Executive Order G-70-25-C

Relating to the Modification of the Certification of the
Atlantic Richfield Balance
Phase II Vapor Recovery System

EXECUTIVE ORDER G-70-25-C
ATLANTIC RICHFIELD COMPANY BALANCE PHASE II
VAPOR RECOVERY SYSTEM

Executive Order G-70-25-C
ARCO Phase II Balance
Vapor Recovery System
Component List

EXHIBIT 1

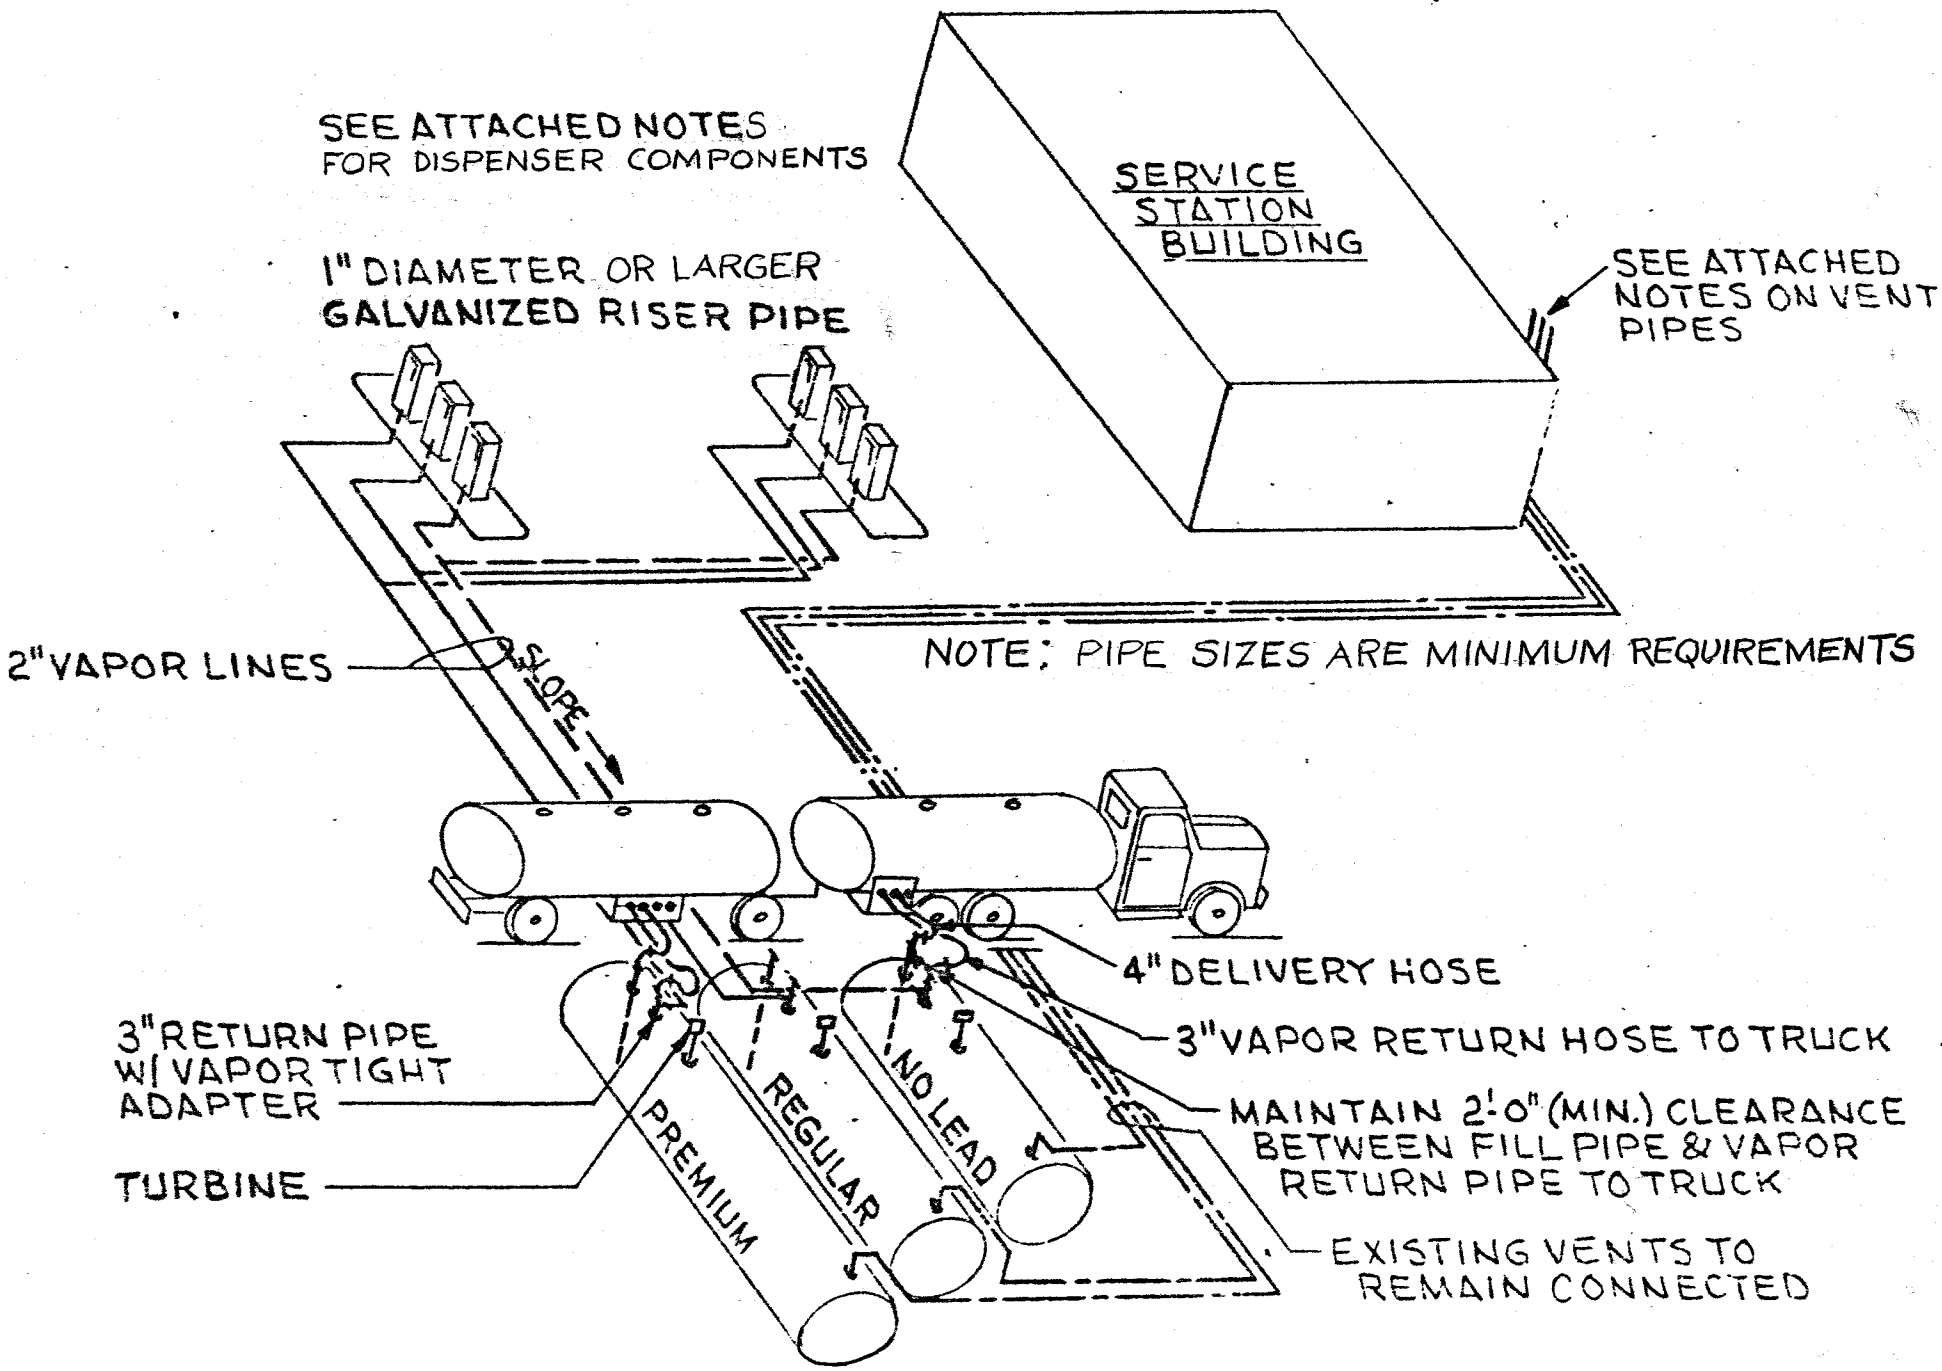
IT IS ORDERED AND RESOLVED: That the certification Executive Order G-70-25-B issued on August 3, 1979 for the Atlantic Richfield balance Phase II vapor collection and disposal system is hereby modified to include OPW-7VC nozzles as alternate nozzles. The system hereby modified is certified to be at least 95% effective in self-serve and/or attendant use at gasoline service stations in conjunction with Phase I vapor recovery systems which have been certified by the Air Resources Board. The system is described in Exhibits 1 and 2, attached hereto.
